APPLICABILITY: 2012-16MY Impreza
 2013-17MY Crosstrek
 2014-18MY Forester
 2015-18MY WRX and WRX STI

SUBJECT: HVAC Blower Fan Inoperative

NUMBER: 10-96-19
DATE: 12/13/19

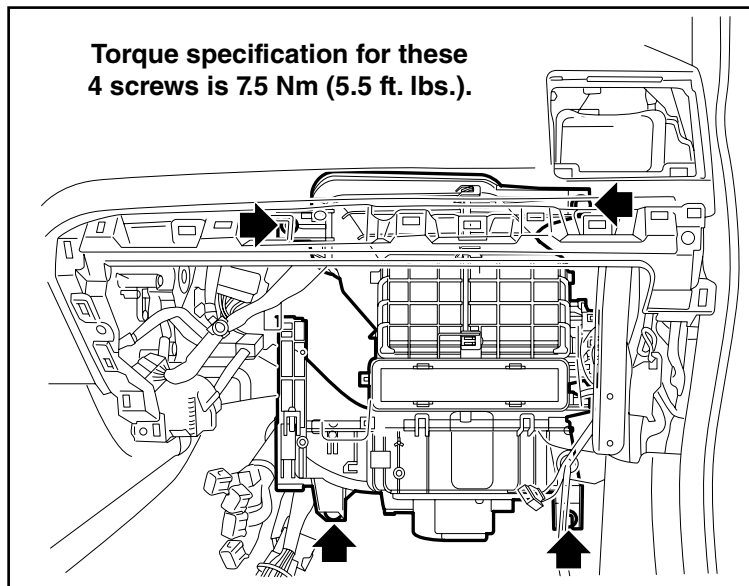
This bulletin announces availability of new HVAC blower motor unit assemblies developed to address isolated concerns of the blower motor becoming inoperative. If this issue occurs on models with Auto A/C, the blower fan may become totally inoperative. If this issue occurs on models with Manual A/C, the blower fan may operate on high speed only. The root cause of these conditions is water intrusion into the blower motor causing rust and corrosion to develop. Over time, the blower motor may begin to draw more electrical current to operate. If that occurs, the additional draw can cause the related fuse and/or the blower resistor to fail. To address this condition, additional packing has been added to improve sealing of the blower unit case along with development of a new style cabin air filter which also incorporates improved sealing.

Description	Part Number	Note
BLOWER & COOLING UNIT	72210FJ033	Models w/ AUTO A/C
	72210FJ043	Models w/ MANUAL A/C
CABIN AIR FILTER **	72880FJ000	For use with new blower units

****NOTE:** The new filter, p.n. **72880FJ000** can be used in place of the prior p.n. **72880FG000** but not vice-versa.
